Proposed Temporary Open Storage and Warehouse for Storage of Vehicle Parts with Ancillary Vehicle Repair Workshop for a Period of 3 Years at Lots 1358 RP & 1359 in D.D.78, Lin Ma Hang Road, Ta Kwu Ling, N.T.

Application No. A/NE-TKLN/114

Response to Comments

DRAWING NO.	FIGURE 1
REV.	A
LLA 顧問有限公司 Consultancy Limited

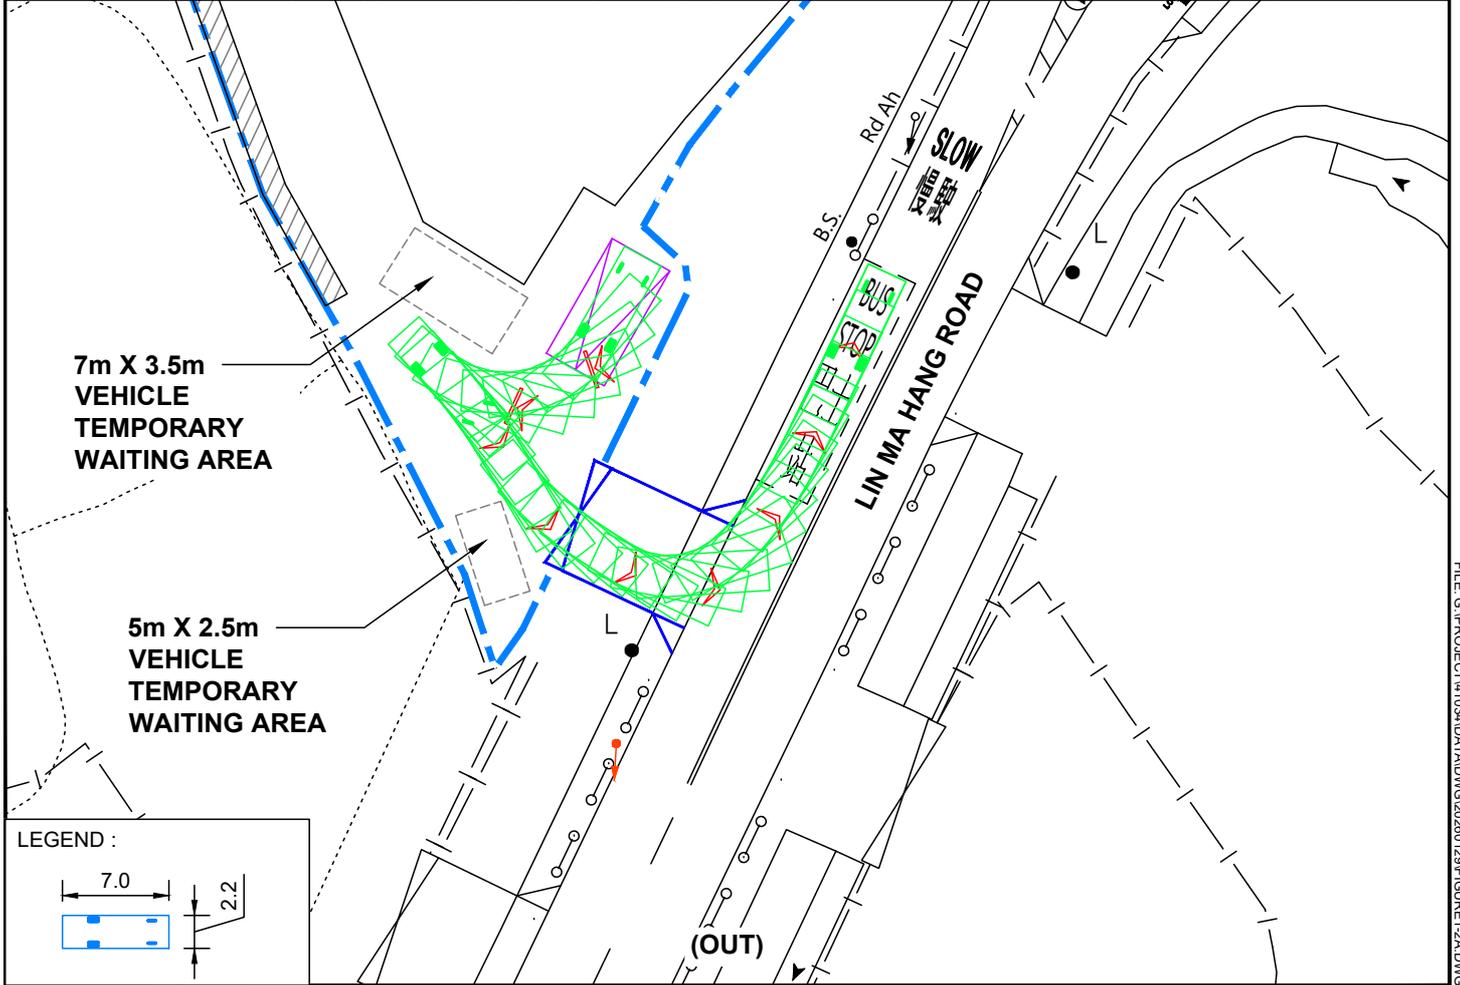
Comments	Responses
Comments from Transport Department via Planning Department's email on 22 January 2026	
1. The egress route of LGV encroached the kerb on slope which is undesirable. The applicant should review and revise the run-in/out design;	Noted. The width of the vehicular access is slightly widened to 6.0m to improve the turning. Please refer to Figure 1A for the updated layout and Figure 2A for the updated swept path.

2. As the proposed run-in/out is close to the existing bus stop. The applicant should provide management measures to maintain the sightline;	Taking into consideration of the sightline issue for the egress vehicle to turn left onto Lin Ma Hang Road. It is proposed to restrict the outgoing traffic to turn-left only. The proposed pair of traffic signs (TS132) is shown in Figure 1A .

3. The applicant should overlay the proposed planting area and temporary waiting/ parking in the swept path layout plan to ensure that the ingress/ egress routes would not be obstructed; and	Noted. Please refer to the updated Figure 1A and 2A for the details.
